SERVICE BULLETIN

Title: Cutler Hammer Chiller Starters

Models Affected: 19/17DR, DM, DK Low Voltage Machines

Number: C9105

CONTROL DISC
OPTIONS HI-H3

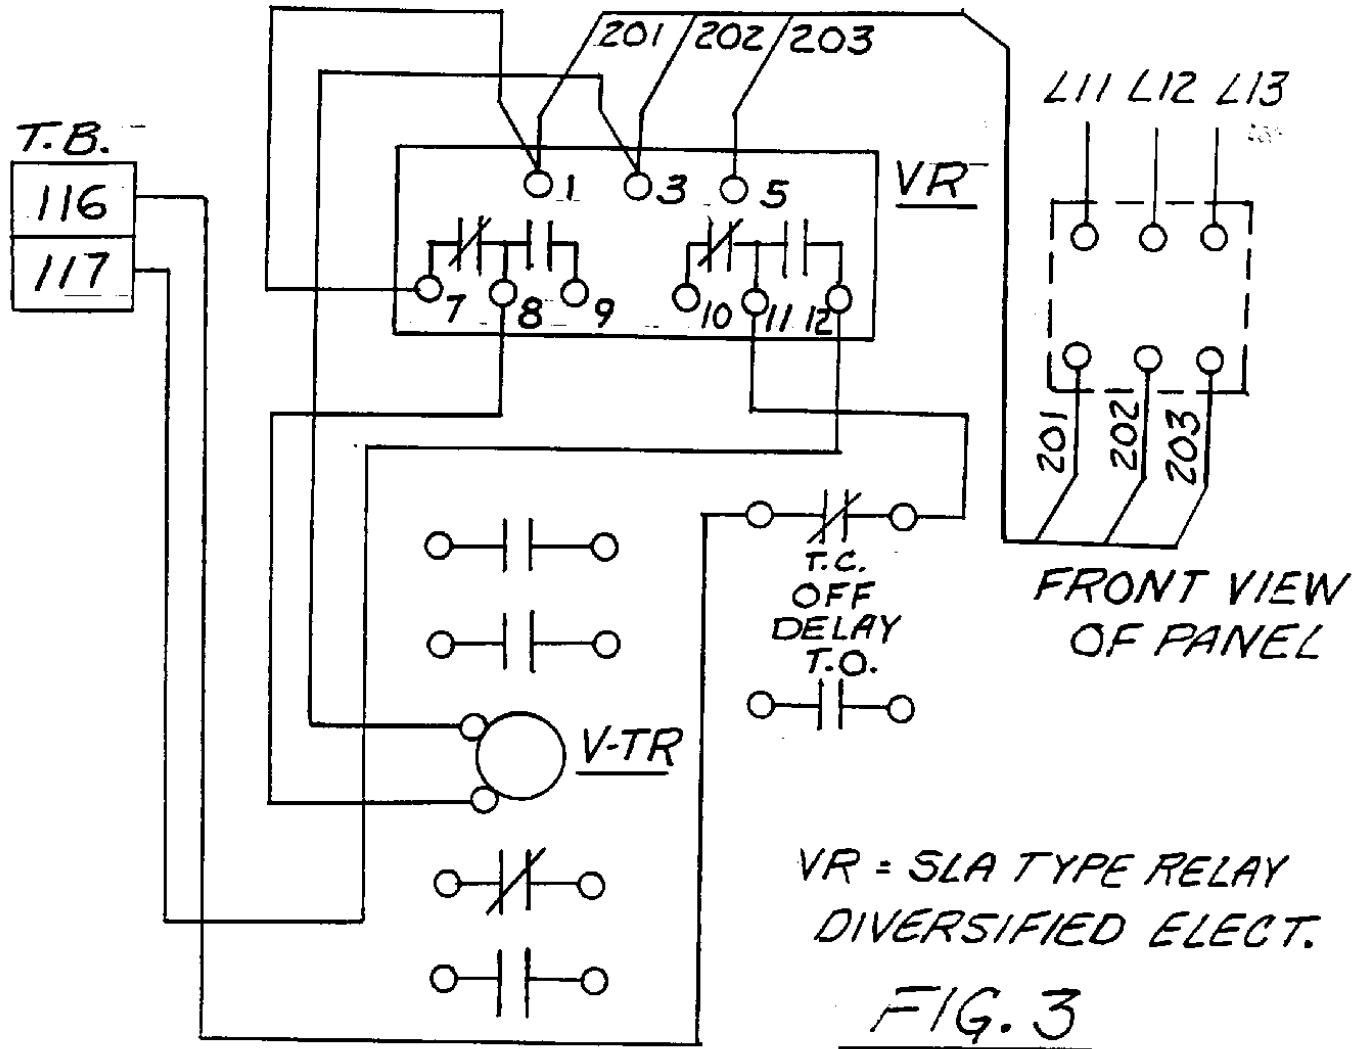
*** If motor terminal leads are reversed to obtain correct rotation of the motor, the phase failure relay must be rewired accordingly ([fig. 3](#)). ***

When 3-phase power of the proper voltage ($\pm 15\%$ of the motor nameplate voltage) is applied to the starter in phase sequence A,B,C, the light on the phase relay will be "on" which indicates that it is energized and operating properly. If the 3-phase power is in incorrect sequence, the light will be off. Reversing wires 1 and 3 on the relay to energize (note that reversed phase sequence will cause the motor to run backwards).

Figure 1

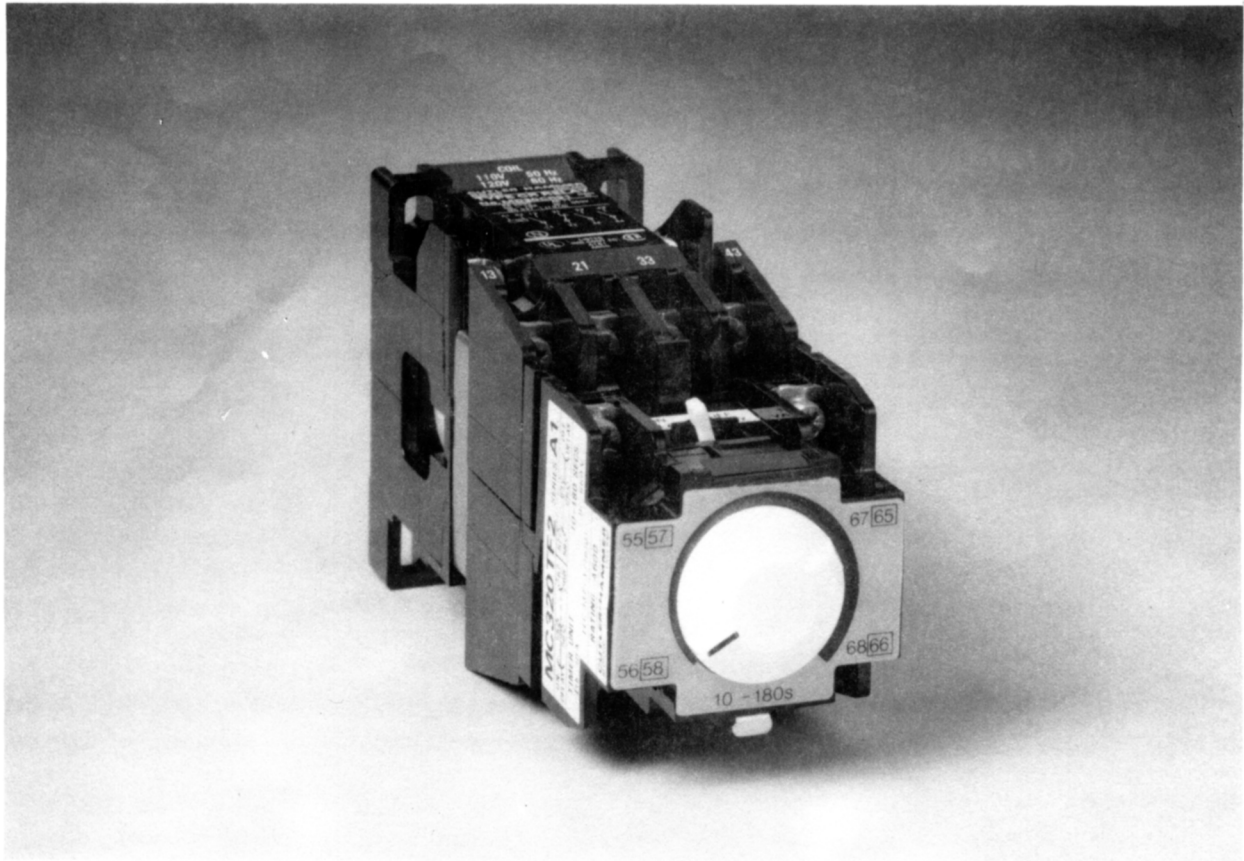
4. The ICR and transition timing relay assembly has been changed. The old style is black in color (fig. 1) and the new style is light grey and larger in size (fig. 2). The mounting holes for the two

styles are the same. If an old style unit has to be replaced in the future, the new style will fit without modification. The transition timing relay is mounted on the front of the ICR. On top of both style timing relays is a selector switch which can be put in the on-delay or off-delay position. For our purpose the switch must always be in the on-delay position. If it is not, the compressor motor will stop in about 90 seconds and a code 74 will be displayed on the 3200MP (failure of starter to complete transition). A plastic sleeve has been placed on the switch to prevent it from inadvertently moving from the on-delay to the off-delay position. The new style unit has been installed on all starters produced after August 1990.
